SSD 5093: STAGED DEVELOPMENT APPLICATION FOR STATE SIGNIFICANT DEVELOPMENT

Response to Submissions
and Additional Information

NOVEMBER 2014

FIGURE 12 – RELOCATION OF THE GAS MAIN

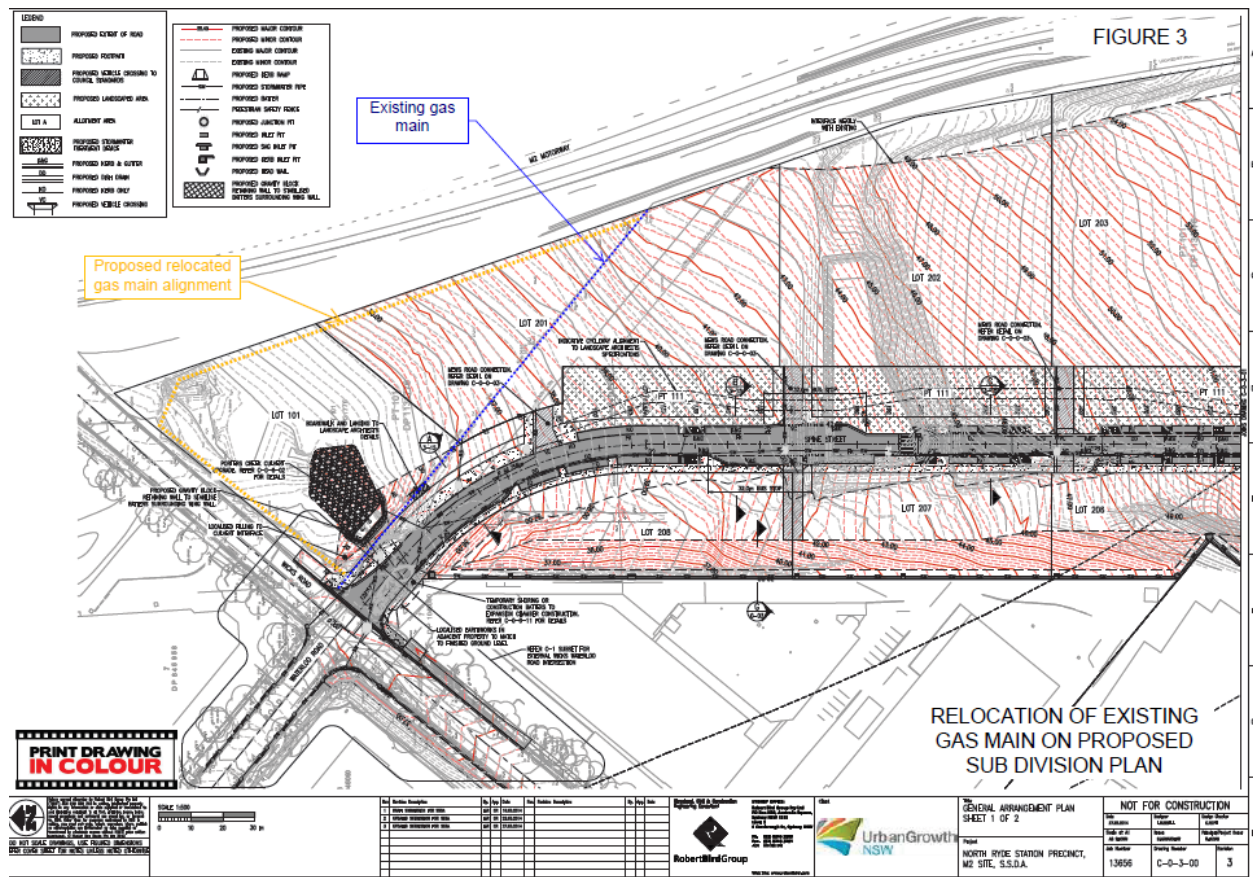
Further information on discussions held with Jemena Gas in relation to the proposed relocation of the existing gas pipeline and the proposed approval pathway for the relocation. Detail how the relocation of	Further detailed information on the proposed relocation of the existing gas main is provided in Section 2.3.1 below. Amended Civil Plans (13656-C-0-3-00 and 13656-C-0-9-

An existing gas main is aligned across the northern end of the M2 site approximately on an alignment parallel to Waterloo Road (refer Figure 1). It exits the M2 site on the northern side of the existing access road and extends westwards along the northern side of Waterloo Road. It is understood that the gas main was relocated to its present location within an unmade road reserve as part of the M2 roadworks. This road reserve was apparently closed in 2001/2 however the gas main was not relocated at that time. It is proposed to relocate the gas main along the eastern and northern boundaries of the M2 site and remove the existing gas pipeline (refer Figure 2).

The gas main is being relocated because it would be aligned through a proposed development lot on the M2 site and would significantly reduce the development potential of this land.
